Advice regarding 22/3139/FUL - Bank stability and improvement works including sheet pile installation, grading of bank, reinstatement with engineered fill, replacement of concrete surfacing and joints and extended drainage pipe to west and North banks.

Thames Young Mariners Base, Riverside Drive, Ham, Richmond, TW10 7RX

EA Planning Response Document

Document Number: C3123-LAWS-TYM-ZZ-RP-C-0001

3.2.2 2100 Maximum Likely Water Level

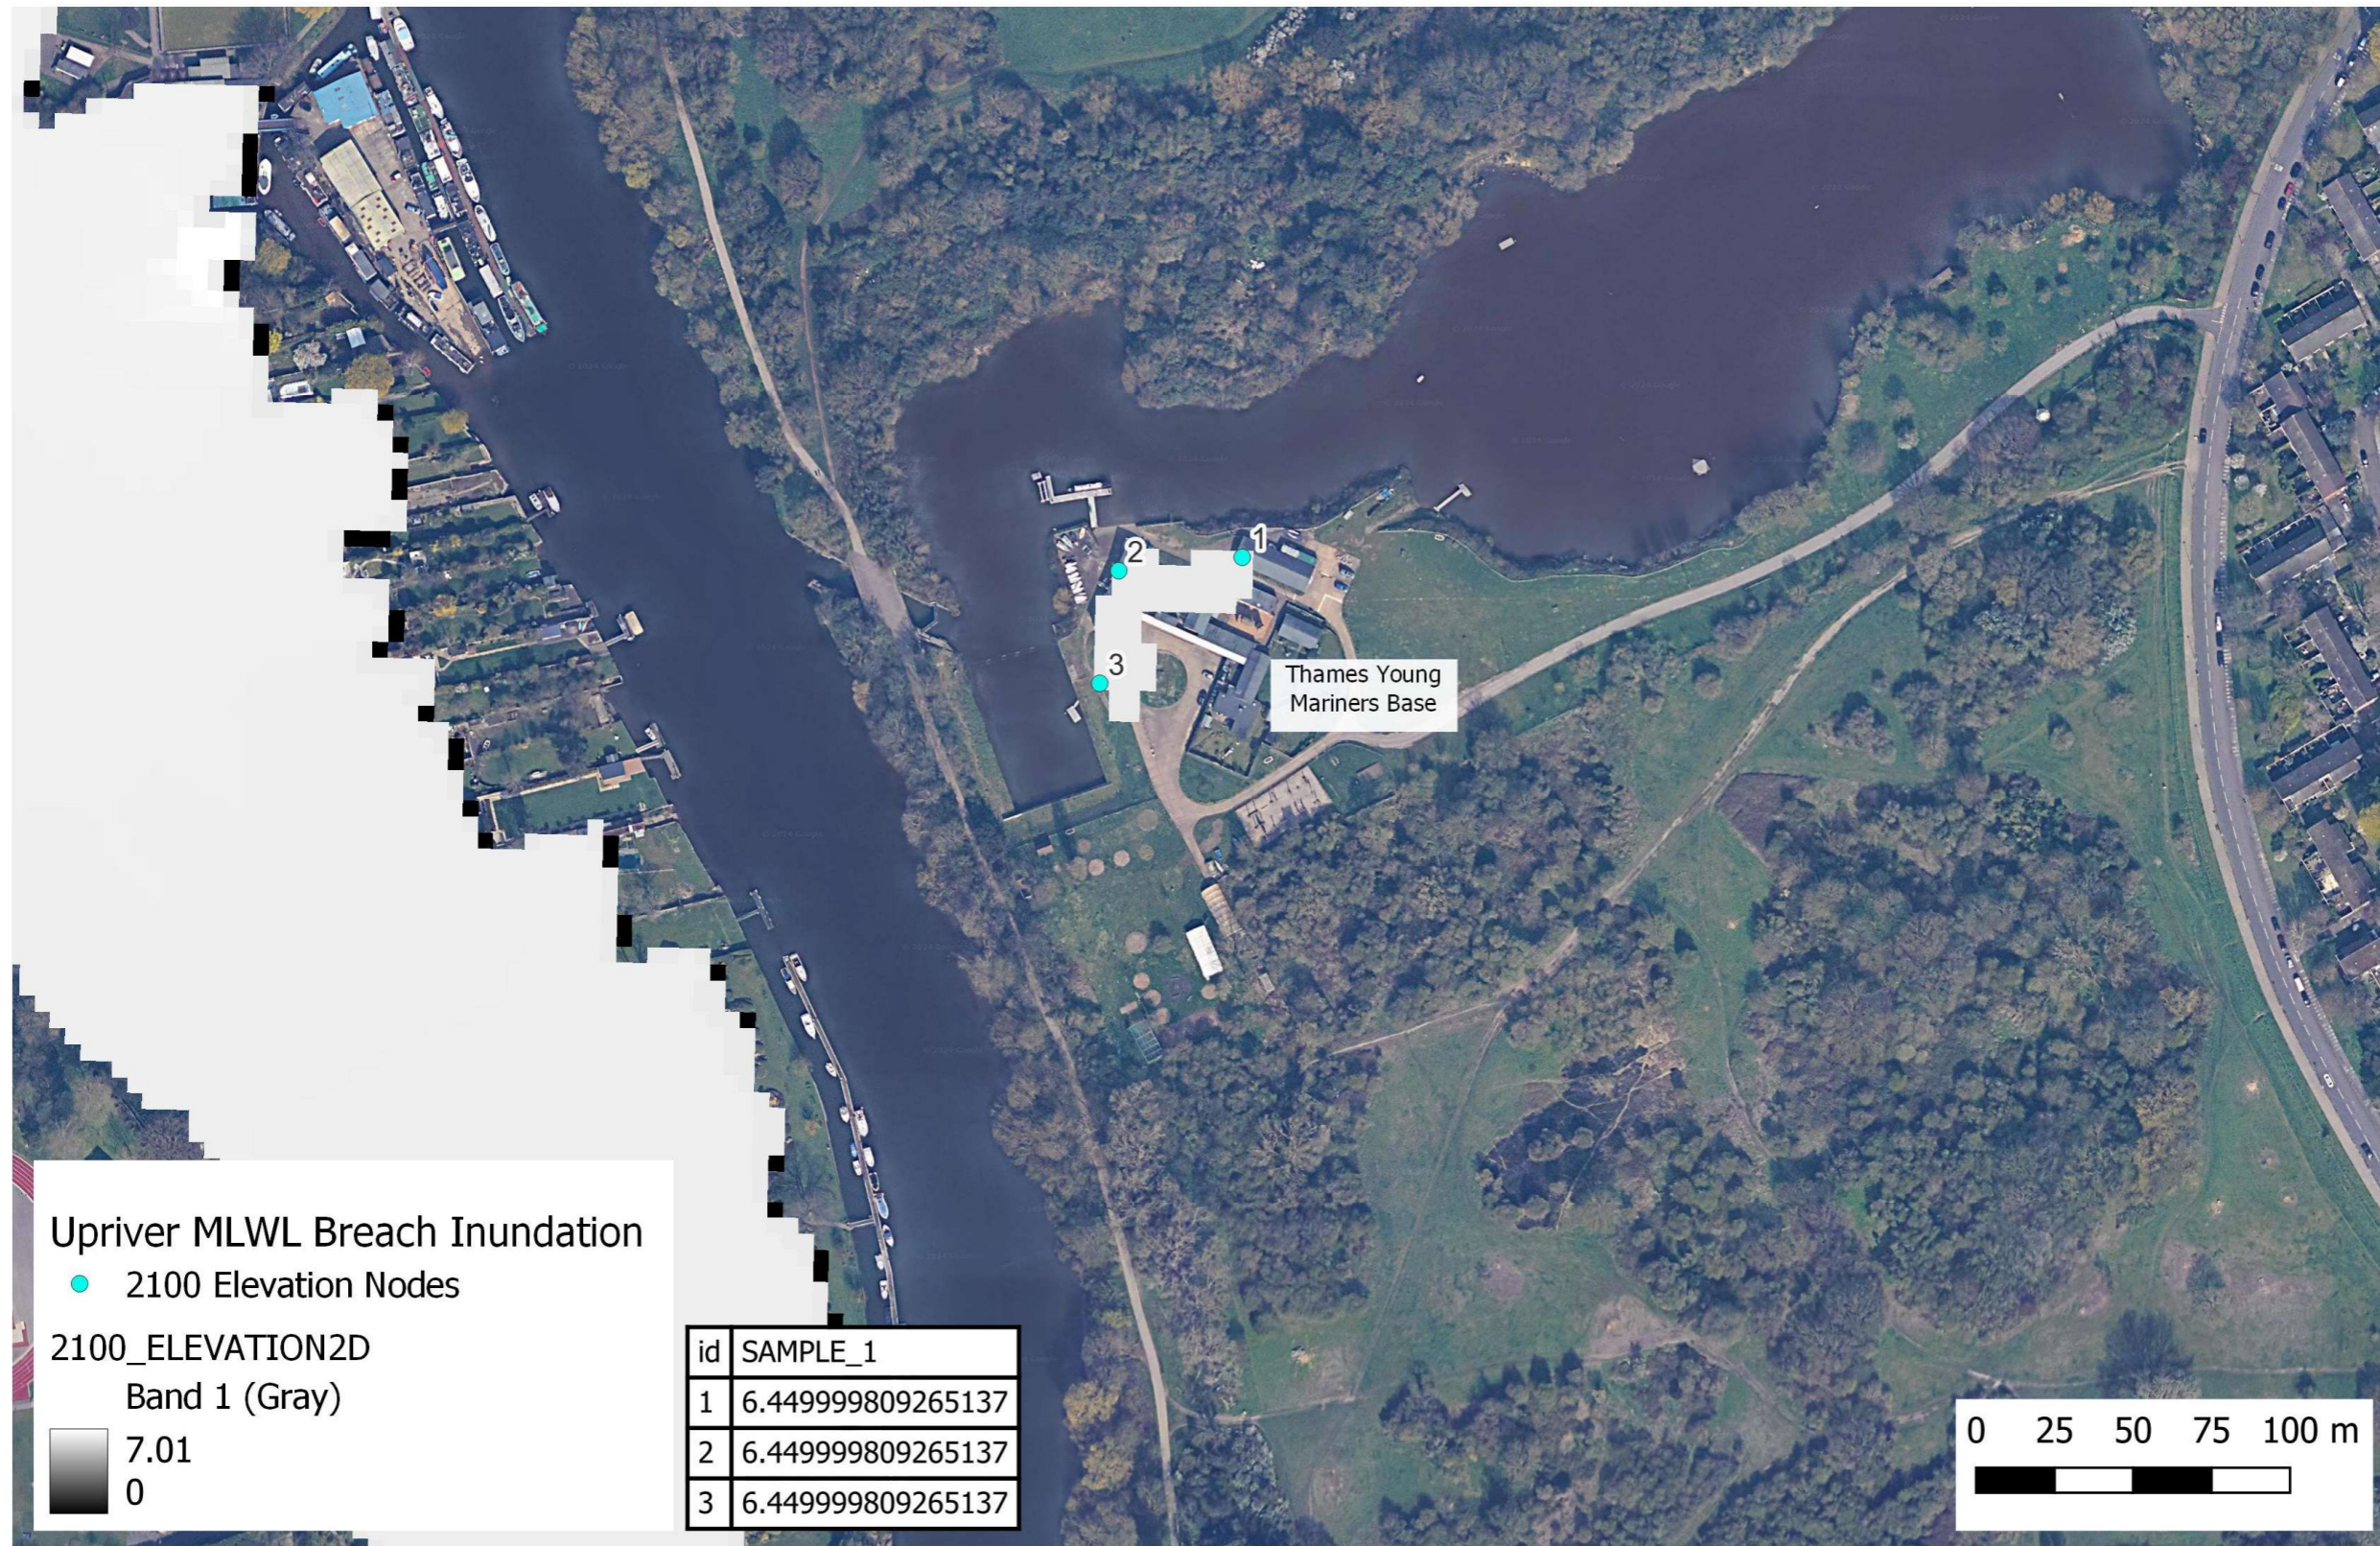
As raised in our formal response to this application dated 2 February 2024 (ref: SL/2023/123082/01-L01), a revised FRA should be informed by our Thames Tidal Upriver Breach Inundation Modelling [2017] and Lower Thames, Jubilee River and River Ash Modelling Study [2020].

Data was requested and received. The relevant elevation 2d grid data was overlaid onto QGIS. Points were plotted onto the data at the closest location to the Thames Young Mariners base as not all of the data covered the site.

The points were used to extract / sample data at each location, a map for each of the sample data has been produced below which includes the point location and extracted / sampled data table.

Figure 10. Proposed works overlaid on new development plans.

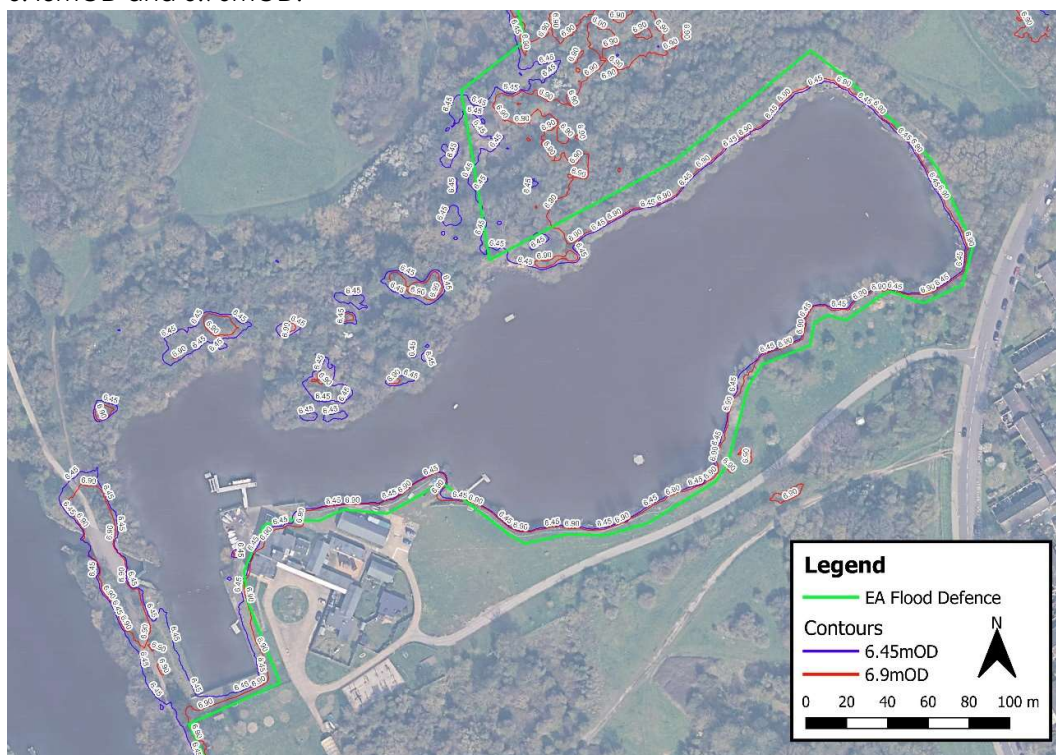
Our previous comment concerning clarification on the location of ground anchors along the North Bank in relation to the new structure remains. This is to mitigate any potential clash between the ground anchors and structure, including foundations.

To address the concern regarding the location of ground anchors along the North Bank, we have provided a revised figure that illustrates the alignment of the proposed sheet pile stabilisation works and the new development. The figure shows that there is no conflict between the ground anchors and the main building footprint of the development. The ground anchors are designed to be installed at an angle and have a typical depth of 3-4 metres below ground level. The new car park, which is located adjacent to the sheet pile wall, will have a shallow foundation that will likely not exceed 1 metre in depth. Therefore, there will be sufficient clearance between the ground anchors and the car park surfacing, even if they intersect slightly in plan view. We believe that this mitigates the potential risk of any clash between the ground anchors and the new structure, including foundations.
